12 SUB2009-00129

OAKLAND HEIGHTS SUBDIVISION, RESUBDIVISION OF LOT 28

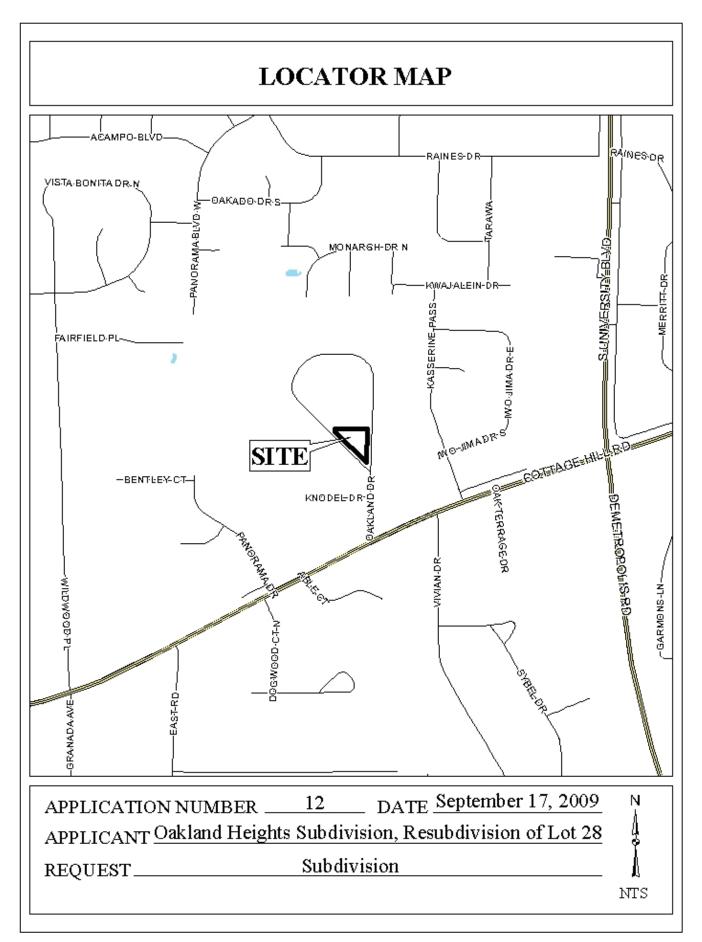
<u>Engineering Comments:</u> Must comply with all storm water and flood control ordinances. Detention will be required; the location of the detention system shall be shown on the final plat. Add note to the plat that clearly states that the maintenance of the detention system is the responsibility of the property owners and not the City of Mobile. Any work performed in the right of way will require a right of way permit.

<u>Traffic Engineering Comments:</u> Driveway number, size, location, and design to be approved by Traffic Engineering and conform to AASHTO standards.

The proposed lots meet the minimum size requirements as regulated by Section V.D.2 of the Subdivision Regulations. The proposed lot size is indicated on the plat in square feet, and this should be retained on the final plat, if approved. The proposed lots also have adequate frontage along a public right-of-way.

The site fronts Oakland Drive, a minor street provided with curb and gutter. The street is depicted with an adequate right-of-way of 60 feet. As this site is a corner lot, dedication sufficient to comply with Section V.B.16 of the Subdivision Regulations regarding curb radii should be required, as depicted on the plat.

The 25-foot minimum building setback line is depicted on the preliminary plat and should be retained on the final plat, if approved.

As this is a residential site, each lot should be limited to one curb cut each, with the size, location, and design of all curb cuts to be approved by City of Mobile Traffic Engineering and conform to AASHTO standards.

- 1) Retention of labeling of the size of the lot, in square feet, or provision of a table on the plat with the same information;
- 2) Retention of the 25-foot minimum building setback line along all public rights-of-way;

- 3) Placement of a note on the final plat stating that each lot is limited to one curb cut each, with the size, location, and design of all curb cuts to be approved by City of Mobile Traffic Engineering and conform to AASHTO standards;

- 4) Dedication sufficient to comply with Section V.B.16 of the Subdivision Regulations regarding curb radii;
- 5) Placement of a note on the final plat stating that development of the site must be undertaken in compliance with all local, state and Federal regulations regarding endangered, threatened or otherwise protected species; and

- 6) Compliance with Engineering Comments: Must comply with all storm water and flood control ordinances. Detention will be required; the location of the detention system shall be shown on the final plat. Add note to the plat that clearly states that the maintenance of the detention system is the responsibility of the property owners and not the City of Mobile. Any work performed in the right of way will require a right of way permit.
